**RE: Application for a Declaration of Exempted Development under Section 5 of Planning and Development Act 2000 (as amended) for development at Kilberry National School, Kilberry, Athy, Co. Kildare.**

ED/1186.

**Reference No. ED/1186**

**RE: Further Information Response pertaining to our Application for a Declaration for Exempted Development under Section 5 of the Planning and Development Act 2000 (as amended) at Kilberry National School, Kilberry, Athy, Co. Kildare (ED/1186)**

1 East Elevation  
1 : 100

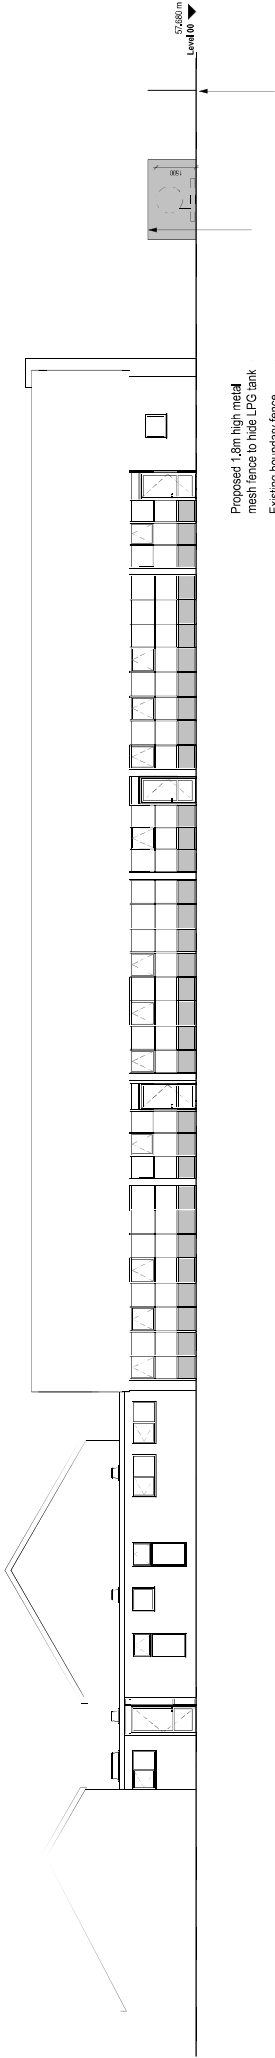
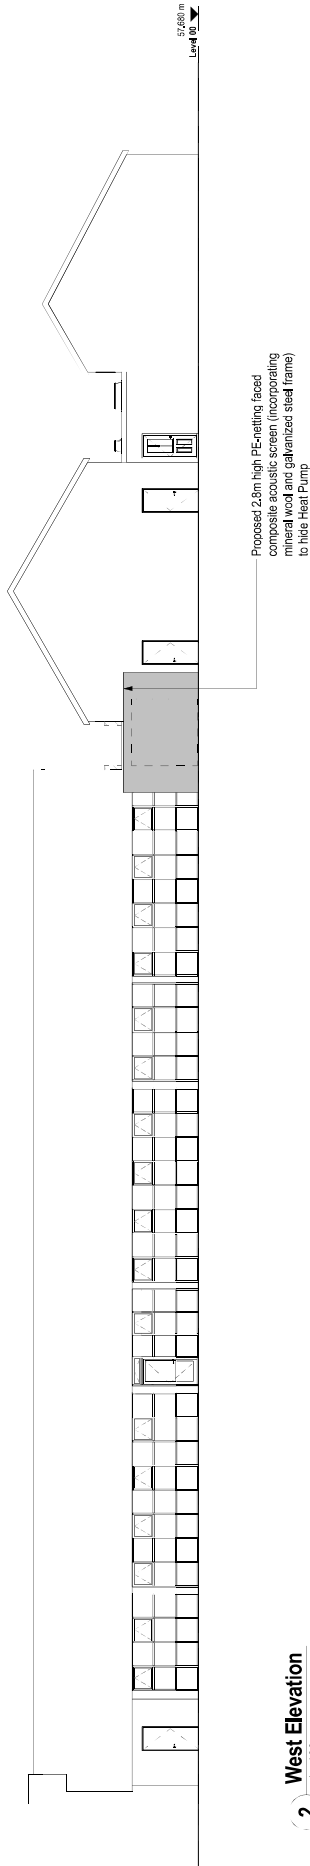
(b) Very little detail has been submitted to support the determination for the '*installation of ventilation hoods onto the external façade to serve internal classroom MVHR units*'. It is noted that no information has been submitted to show either the size of the units or their location on the building. For a determination to be made the applicant is requested to submit elevational drawings of these items, with dimensions.

**BDP Comment:** A revised version of the "Proposed Building Fabric Upgrade Elevations" Drawing is appended to this correspondence which provides greater detail regarding the size and location of the MVHR units on the existing buildings. It can be noted that there are 4no. ventilation hoods located on the East Elevation, and 1no. ventilation hood location on the South Elevation. These ventilation hoods are 300mm (H) x 500mm (W) x 100mm (D) in size, and are to be grey powder coated aluminium in appearance.

Please refer to Drawing: "07KNS-BDP-XX-XX-EL-A-PP0002 (REV\_P02)"

PART PLAN AS PROPOSED

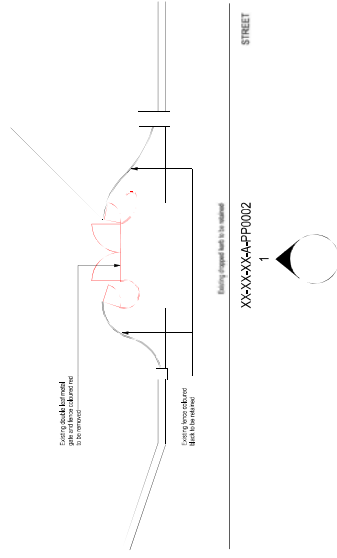
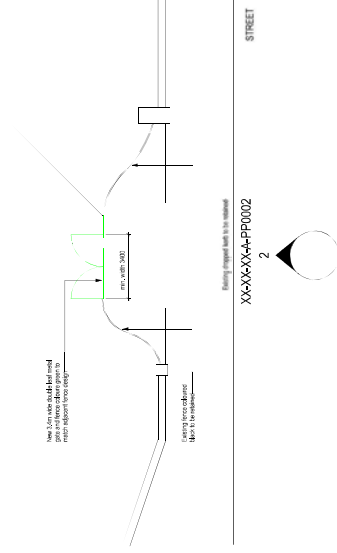
(d) With regard to the item relating to 'amendment of existing gate for vehicular access', it is noted that it is stated on the 'Site Layout Plan' 'new 3.4m wide double leaf metal gate to match existing'. It is also noted that the existing access is pedestrian only. The description, which is the subject of this determination, refers to a 'vehicular access', which does not tally with the description on the drawing which refers to 'the gate to match existing', which is pedestrian. Changes to an entrance are deemed to be works and are deemed to be development. However, a determination whether or not this development is exempted development cannot be made without clarification. The Applicant is requested to clarify the works they are seeking a Section 5 declaration for.

**BDP Comment:** A new "Plan & Elevations of Entrance Gate as Existing & Proposed" Drawings is appended to this correspondence which provides greater detail regarding the existing access gate and the proposed 3.4m wide double leaf metal access gate.

For clarity, the existing access gate is predominantly utilised for pedestrian access however it is also infrequently utilised to provide vehicular access to this part of the school for maintenance purposes. It can be noted that a dropped kerb already exists on the road in this location to facilitate same, and as such this avoids the need for any required modifications to the existing kerb / path arrangement.

Please refer to Drawing(s): "07KNS-BDP-XX-XX-XX-A-PP0002 (REV\_P01)"
